FORREST HOUSE

BLOCK 11 SECTION 7 FORREST

DRAWING NO.	TITLE
WA000	PLAN - LOCATION & DRAWING SCHEDULE
WA004	PLAN - DEMOLITION
WA005	PLAN - SITE
WA007	SOFT LANDSCAPE ANALYSIS
WA008	SHADOW DIAGRAMS
WA009	SHADOW DIAGRAMS
WA010	SHADOW DIAGRAMS
WA011	PLAN - AREA GFA
WA011	PLAN - BASEMENT
WA102	PLAN - GROUND FLOOR
WA103	PLAN - FIRST FLOOR
WA104	PLAN - ROOF
WA200	STREETSCAPE ELEVATION
WA201	ELEVATIONS
WA202	ELEVATIONS
WA300	SECTIONS
WA900	STREET PERSPECTIVES

DRAWING TITLE  
**ELEVATIONS**

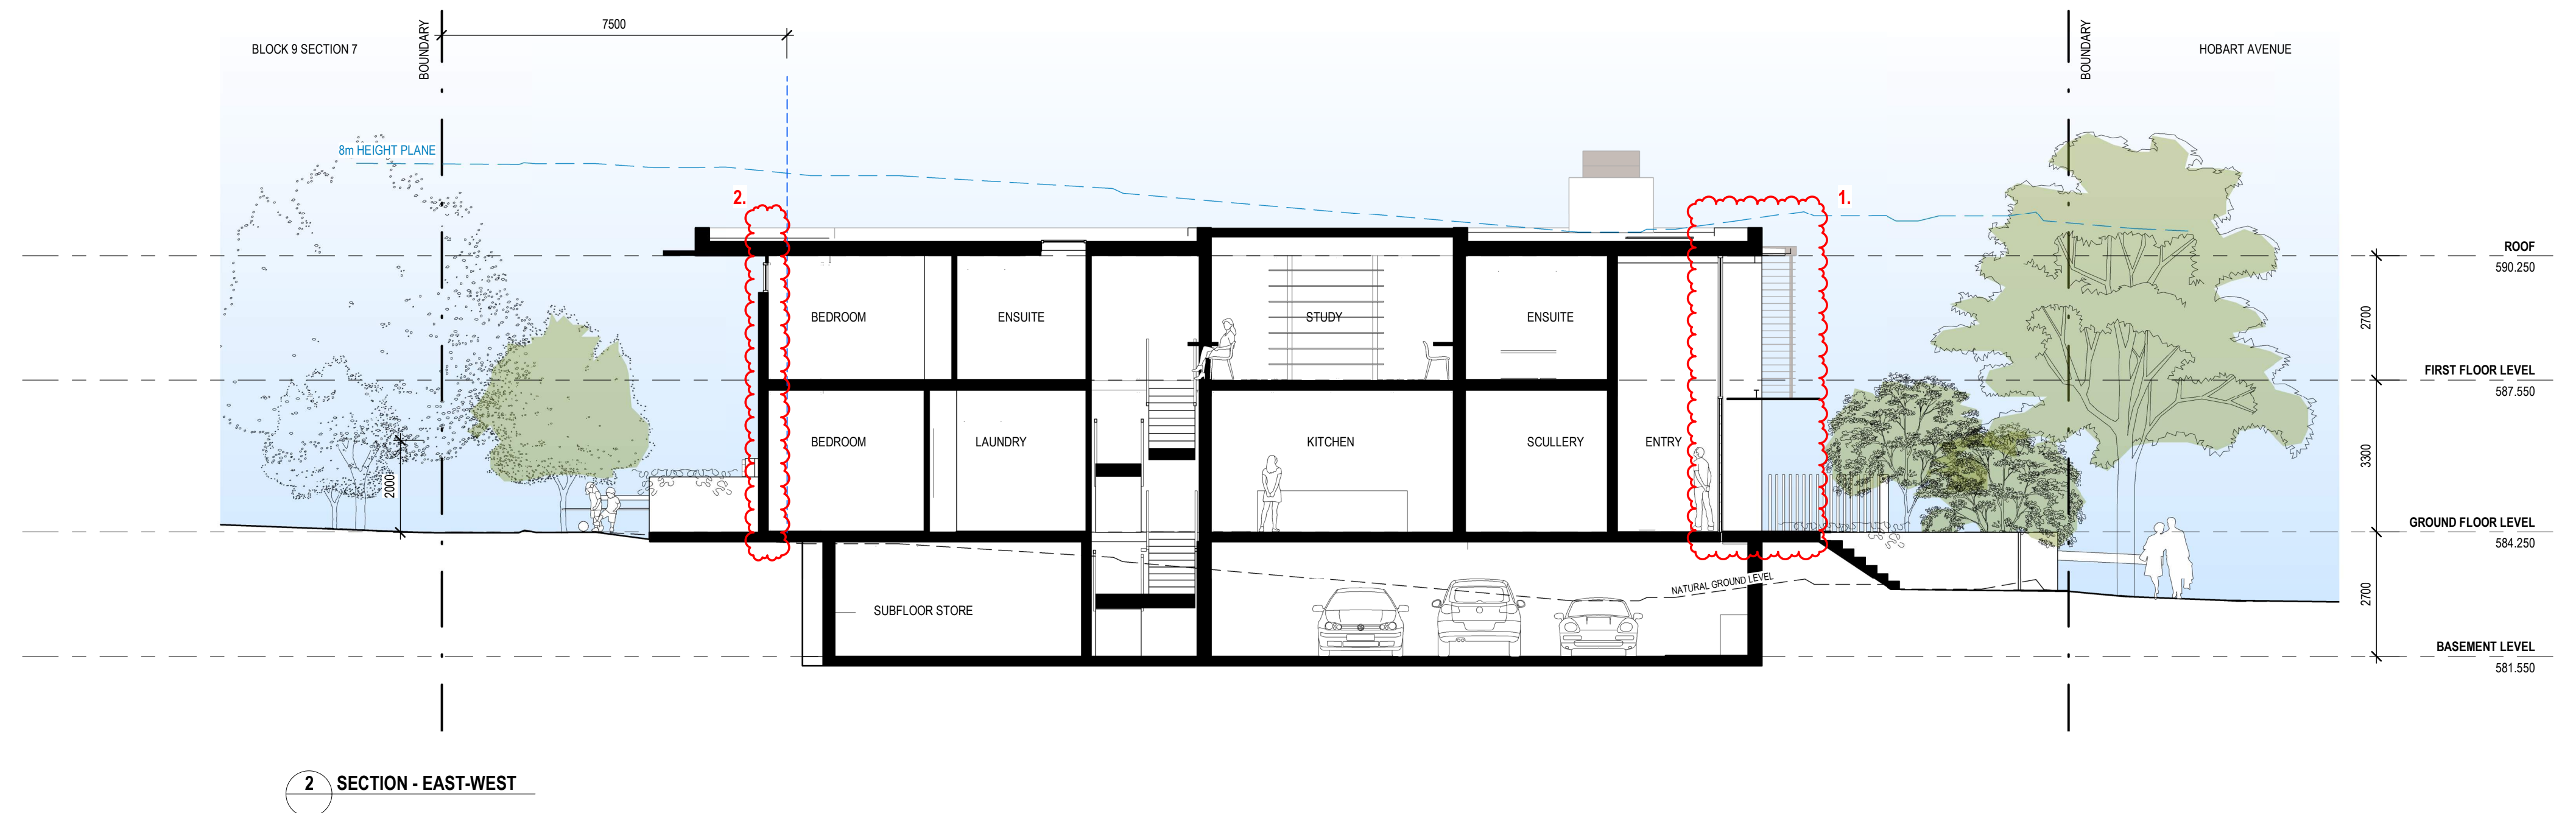
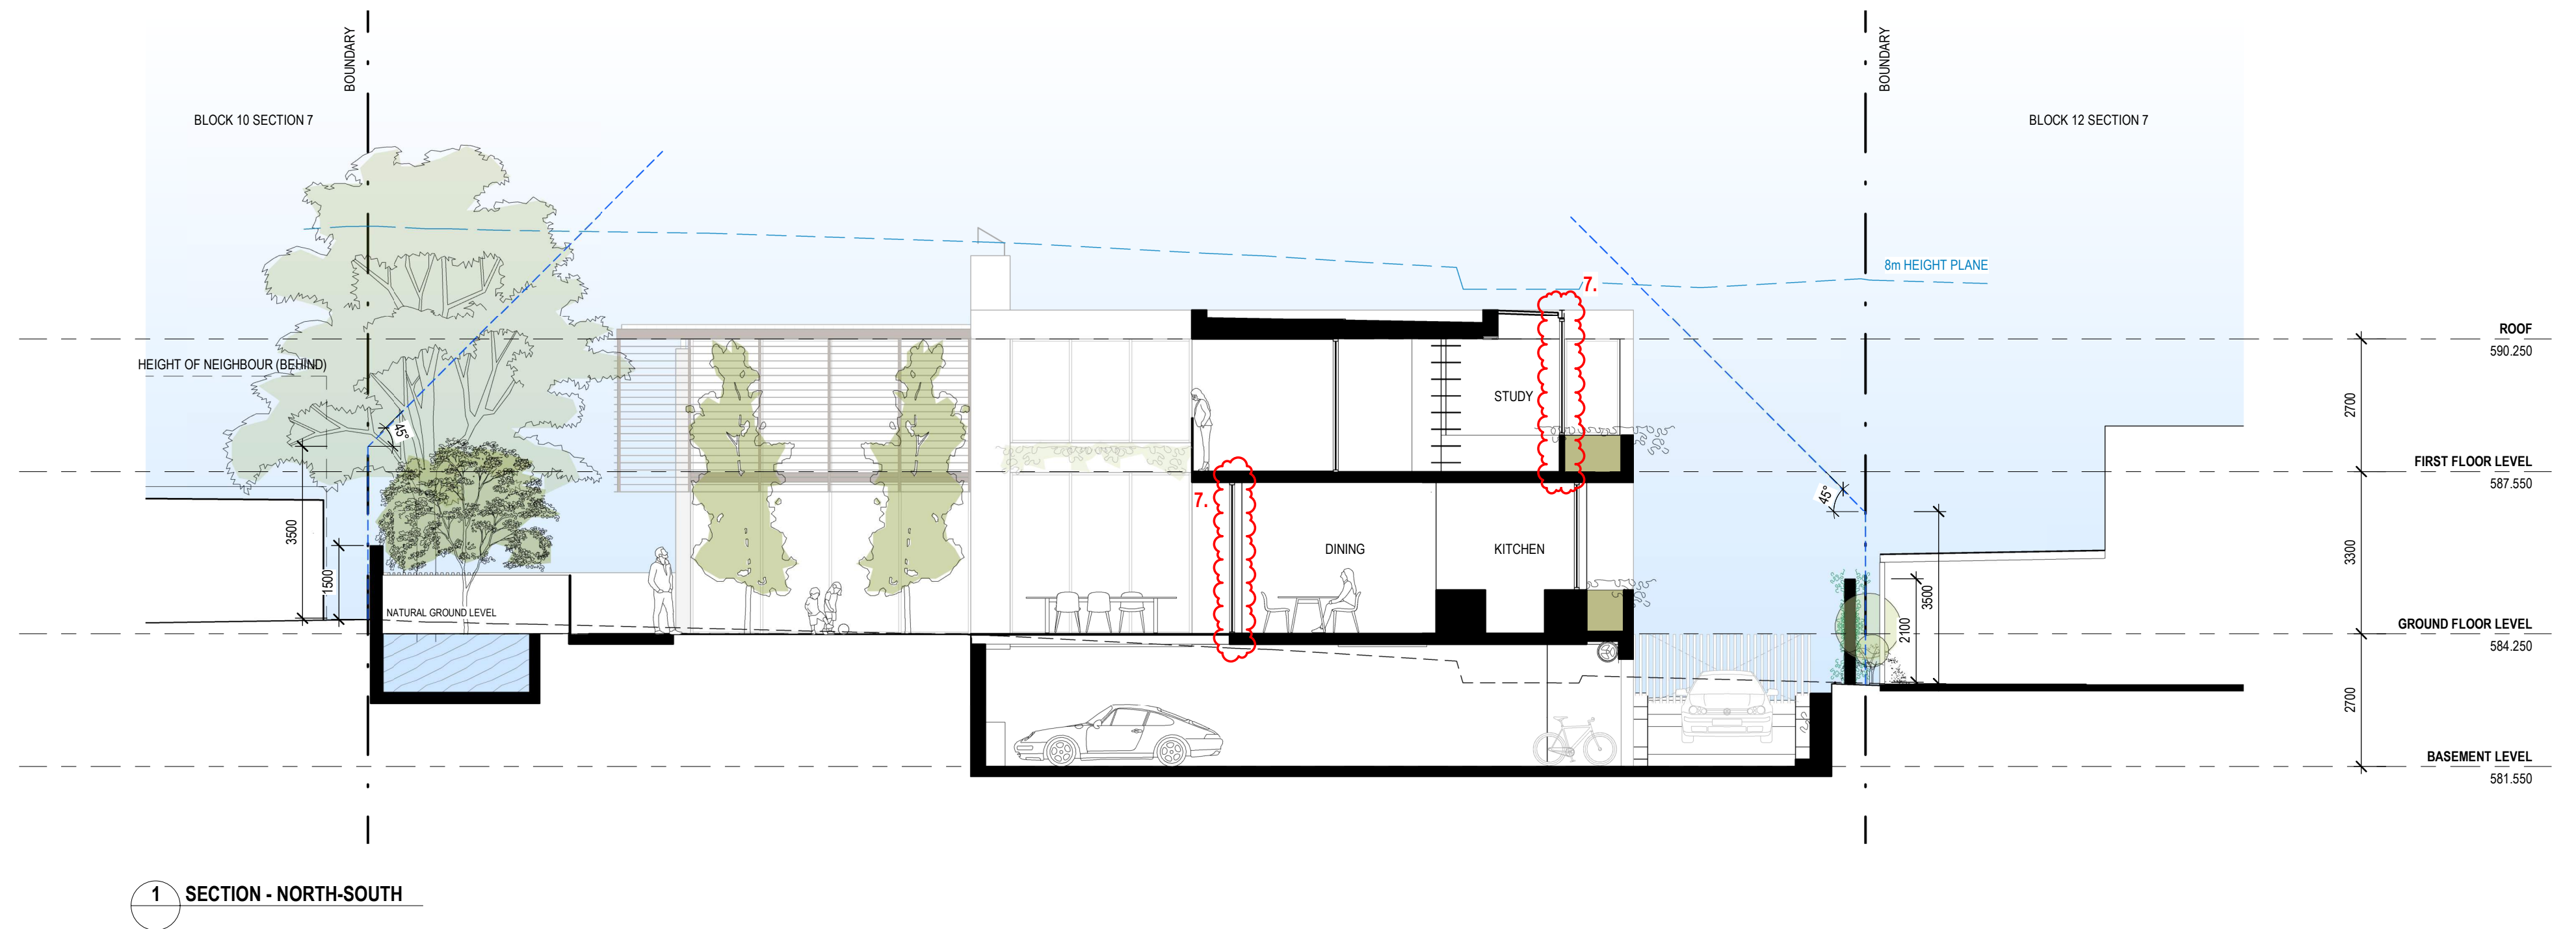
- WORKS APPROVAL - RFI RESPONSE**
- EASTERN WALLS MOVED 240mm WEST TO SETBACK LINE.
  - WESTERN WALLS MOVED 500mm EAST. FACADE ARTICULATION WALL REMOVED.
  - POOL PAVILION WALLS REMOVED. AREA NOW AN UNENCLOSED COVERED AREA.
  - SOFT LANDSCAPING AREA INCREASED, GFA DECREASED.
  - SHADOW EXTENT REDUCED AS A RESULT OF THE BUILDING FOOTPRINT DECREASING.
  - STUDY AND DINING ROOMS INCREASED IN DEPTH. MASTER BED PLANTER REMOVED.
  - SOUTHERN LANDSCAPE ALTERED FOR GREATER VISUAL PRIVACY.
    - FEATURE TREE CENTRED TO MASK VIEWS TO/FROM STAIR.
    - ADDITIONAL PLANTING ADDED TO BOUNDARY WALL.
    - ADDITIONAL LARGER PLANTING ADDED TO KITCHEN PLANTER (REFER LANDSCAPE DOCUMENTS).
